# ADDENDUM NUMBER 5

NEW LOXLEY WATER TREATMENT PLANT

FOR CITY OF LOXLEY

GMC PROJECT NO. CMOB220078(2)

**1A FLOOR PLAN**  
A-101 SCALE: 1/4" = 1'-0"

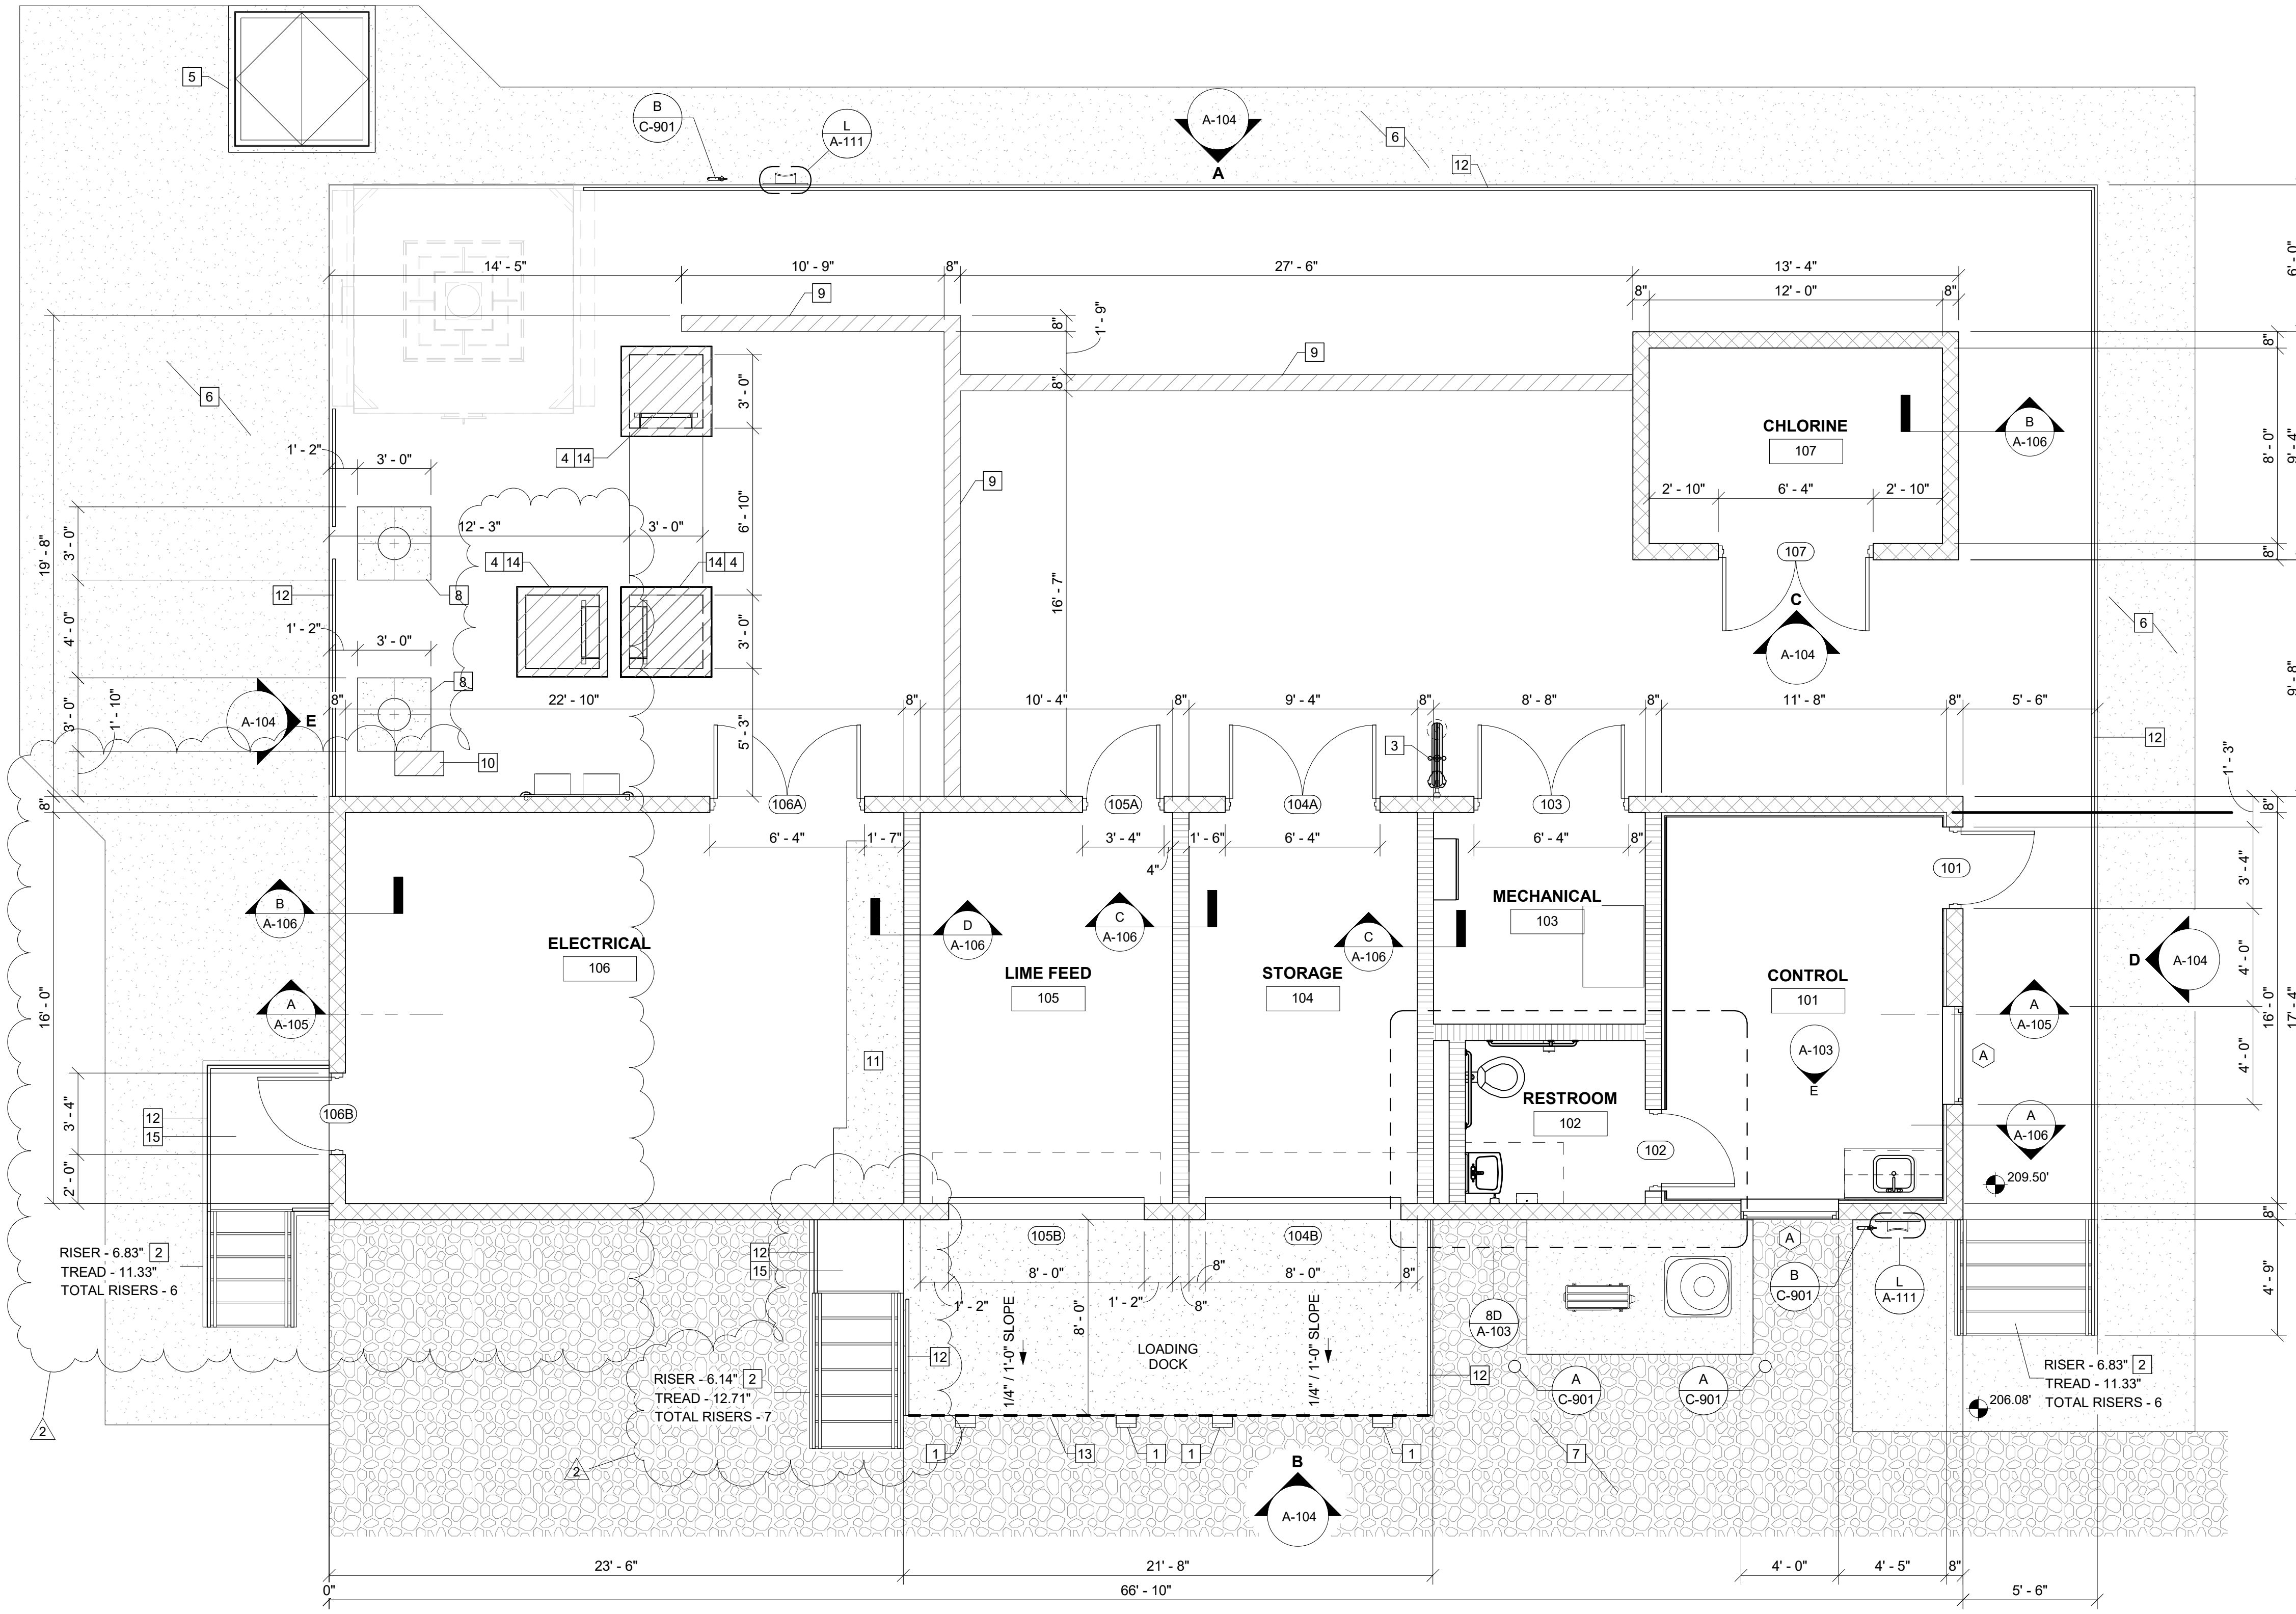
- 9. Electrical Room
  - a. The size of the electrical room has increased and the equipment layout has been modified.
  - b. Additional light fixtures have been included in the electrical room.
- 10. Mechanical
  - a. Two new mini-split HVAC units have been added (revised mechanical drawings in next addendum will reflect this).

CHEMICAL BUILDING  
REFLECTED CEILING  
PLAN & ROOF PLAN  
**A-102**

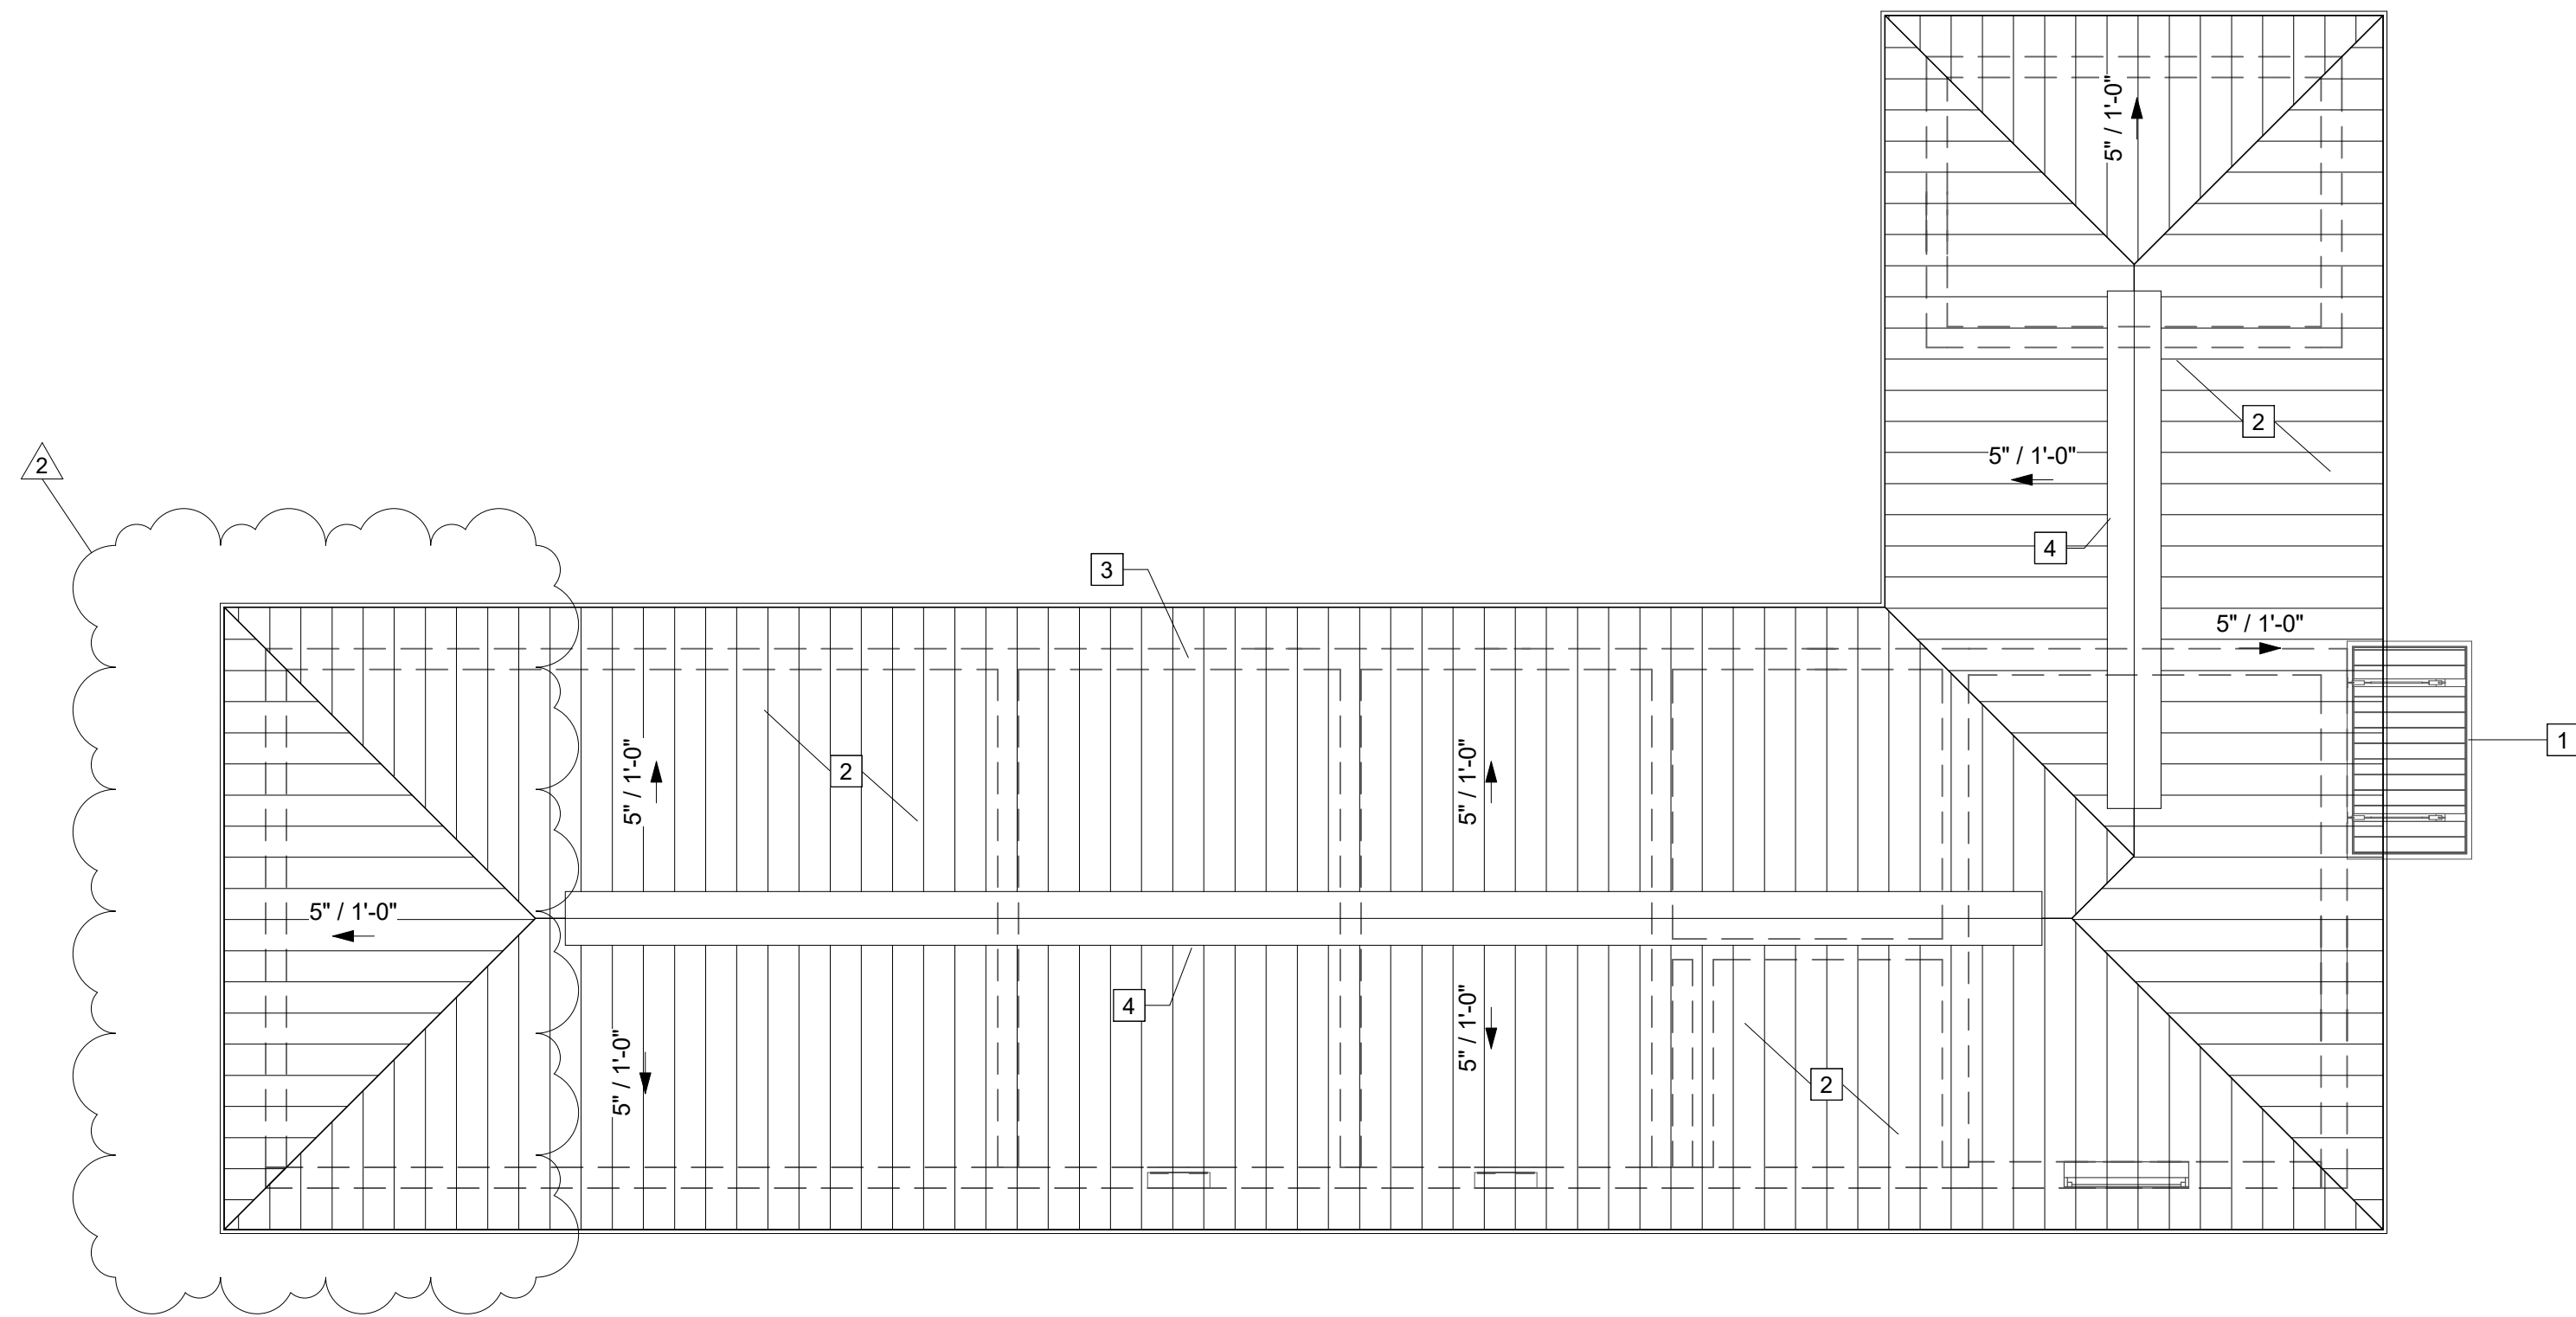
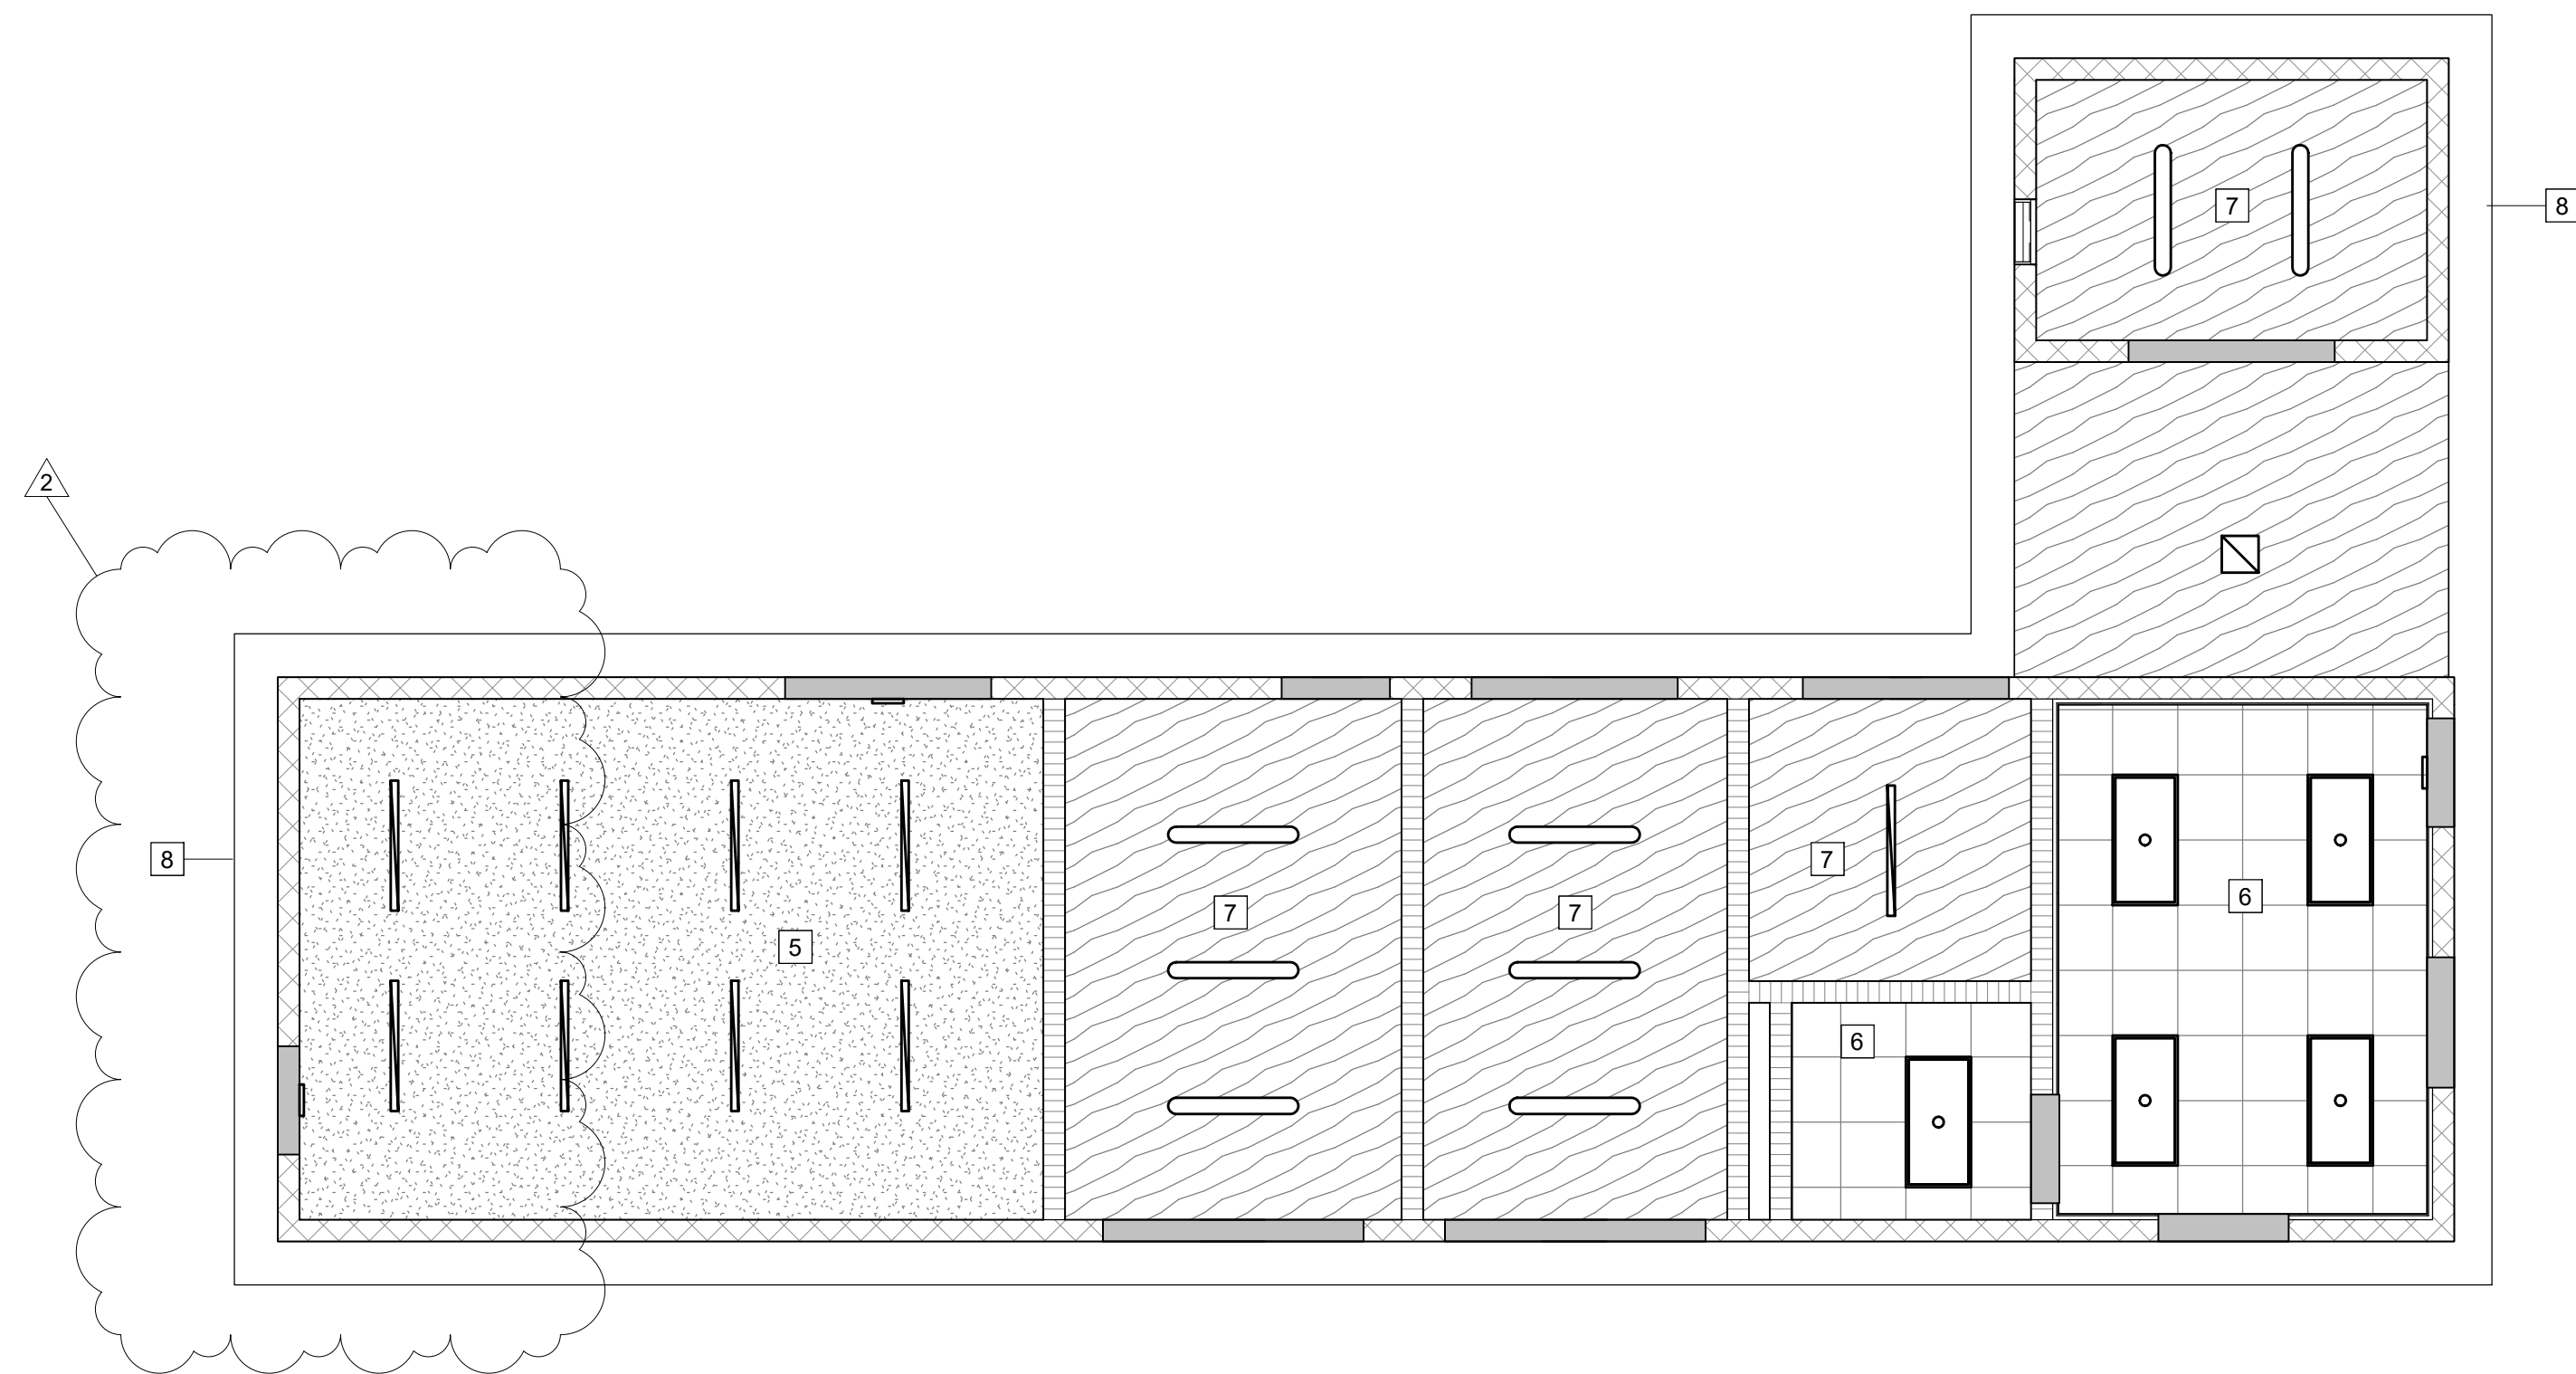
- 6. Lightning Protection
  - a. Lightning Protection layout has been modified to accommodate the increase overall building size.
- 7. Natural Gas Standby Generator 'GEN-1'
